RE: Town of Jackson Wastewater Lagoon, Permit No. WY0021458

On behalf of Protect Our Water Jackson Hole (POWJH), I am pleased to submit this letter in response to the WDEQ's September 16, 2022 public notice inviting comments on the above-referenced pollution discharge permit renewal.

I. Flow Diagram

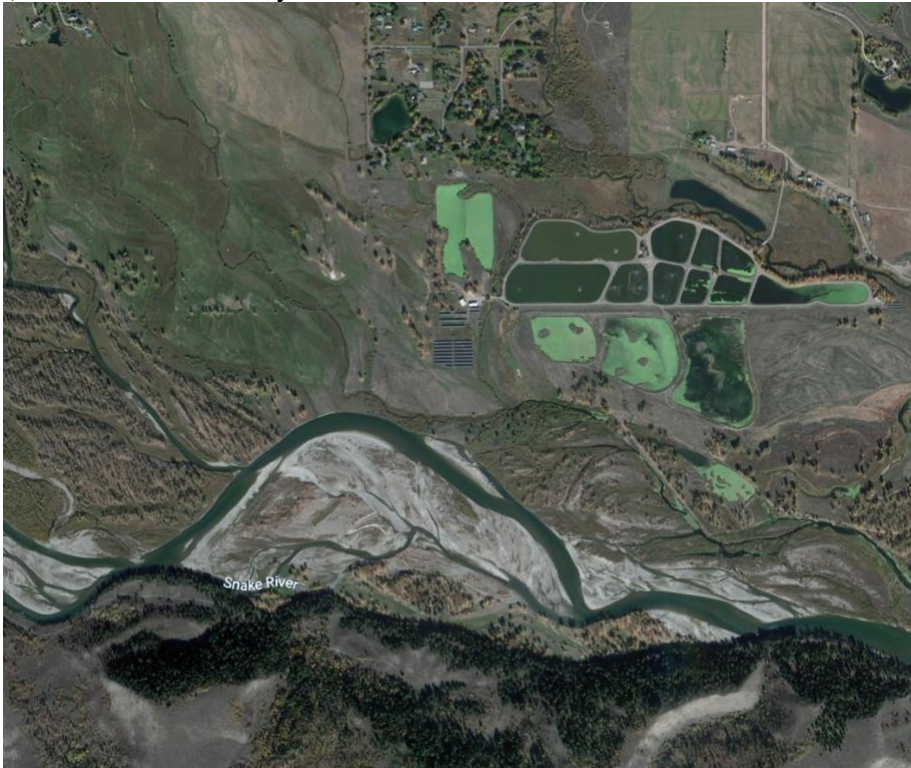
- a) It would be helpful for the public to understand the flow of effluent through the facility by illustrating a flow path with a simple arrow through each pond/facility component.
- b) It appears that the unnamed tributary below the borrow pond, that receives effluent from this facility, either contains or could support fish (and would therefore be considered Class 2AB). What evidence does DEQ have indicating this segment does not contain fish and other aquatic life?

i) Snake River at facility

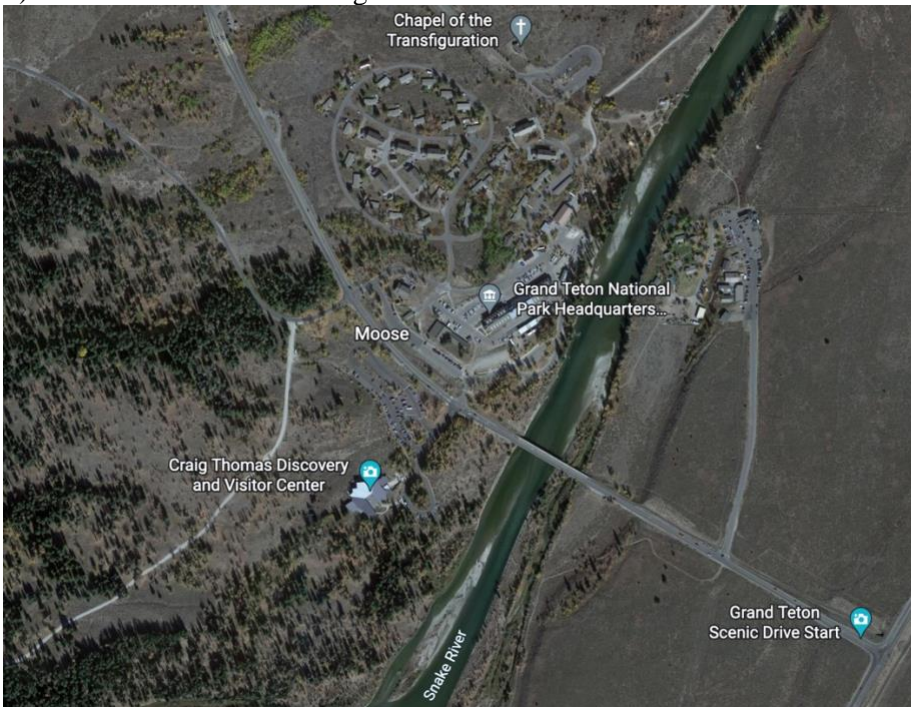
- a) Flow data from the Moose gauge is used to justify the exclusion of an official mixing zone. As evidenced by the included pictures (Google Earth), the nature of the Snake River near the facility (i) is different than at the Moose Gauge (ii). How are the braided nature and variance of flows in the Snake River taken into account when calculating dilution?
- b) This permit states (on Statement of Basis page 5) that water quality based effluent limits for ammonia are being established per mixing zone rules, but this statement appears to be inaccurate as no effluent limit exists for ammonia.
